Subject: RE: Hook Lane reserved matters

I have looked at this application P/132/20/RES which I see also has now been superseded by P/79/21/RES which is a resubmission of the former. Both are following outline P/30/19/OUT approved with 106 agreement.

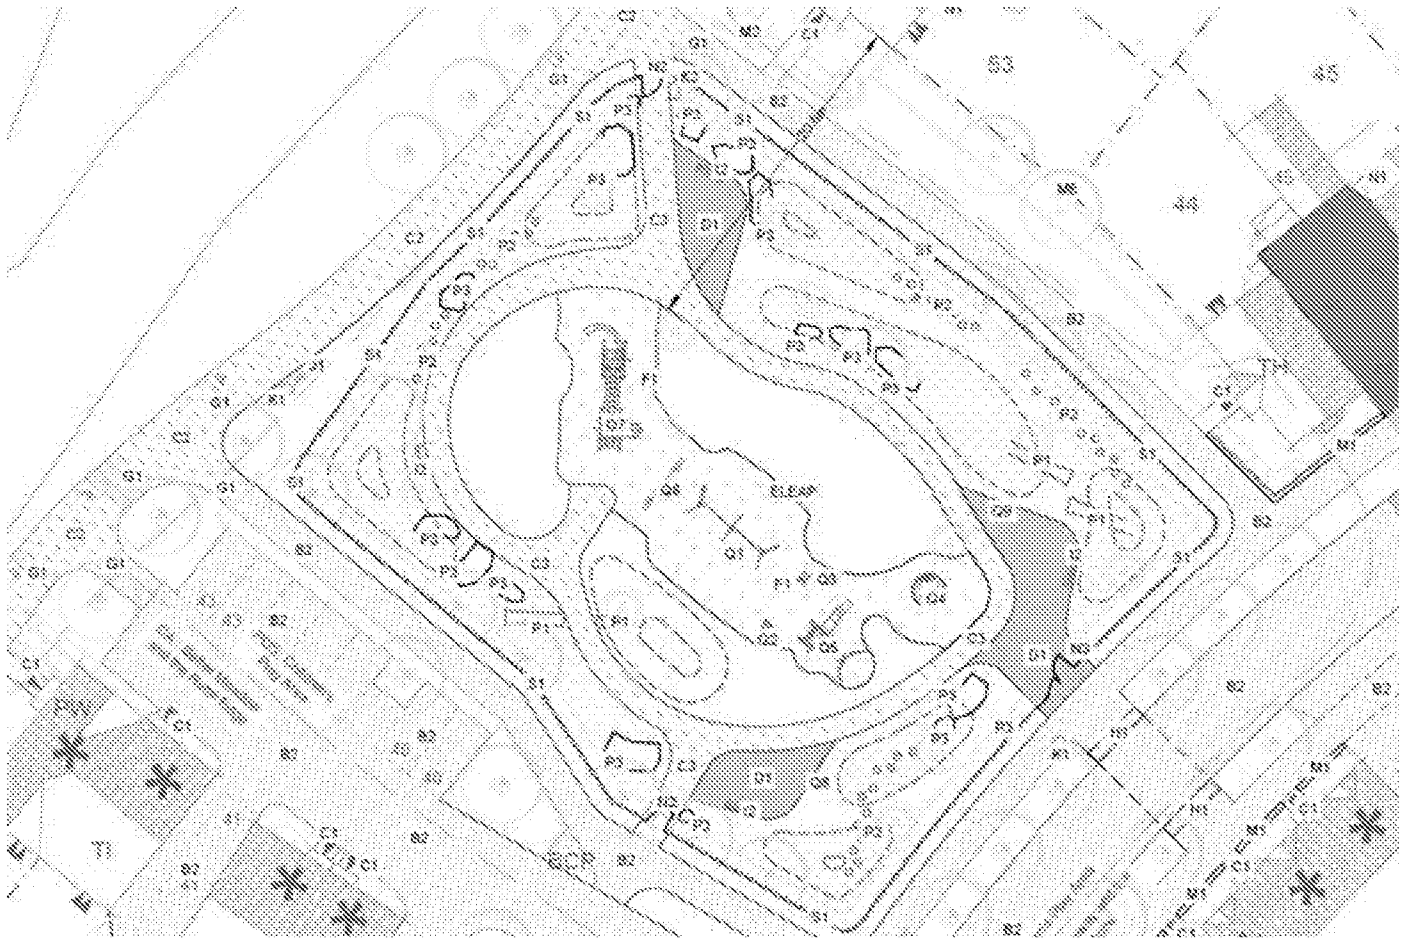
- The drawings are inadequate in detail and would be required to be shown as a separate play drawing rather than encompassed within the Hardworks Plan 5/71/67/-RM-06-Rev C.

The play drawing should be provided in plan form and also include visuals of the equipment choice, the surfacing and connectivity of this to the wider pathway network.

- The play provision as agreed under P/30/20/RES was for an ELEAP – Enhanced Local Equipped Area of Play and was to include 9 play experiences as a minimum requirement. The play shown under Hardworks Plan 5/71/67/-RM-06-Rev C in my opinion does not include sufficient or varied enough play offer. (for ref: items shown would appear to be from the Sutcliffe Play range) This play area is to cater for a large number of new dwellings (excluding the existence of the local Parish play area) and is intended to be a quality play area, fitting for location in material choice, equipment provision, accessibility and play offer.

- Hardworks Plan 5/71/67/-RM-06-Rev C. does not include detail of seating, bins, signage or safety surfacing. Pathways need to be detailed and surfacing of these approved. The fencing is shown as 'stock proof fence' which I would not consider to be appropriate for a play area – with or without planting to the perimeter. Gates need too be shown with self-closures and access for maintenance operations. These details have not been provided.

The Parish Council feels the play equipment suggested is not innovative. At the Advisory Group we suggested that whatever is provided should complement, not replicate, the other offerings in Pagham. The play equipment chosen is very traditional (swing, roundabout, see-saw, springer) whereas we were hoping for something different such as water play, skate ramp, scooter track. There is a traditional play area maintained by the Parish Council opposite the development site.
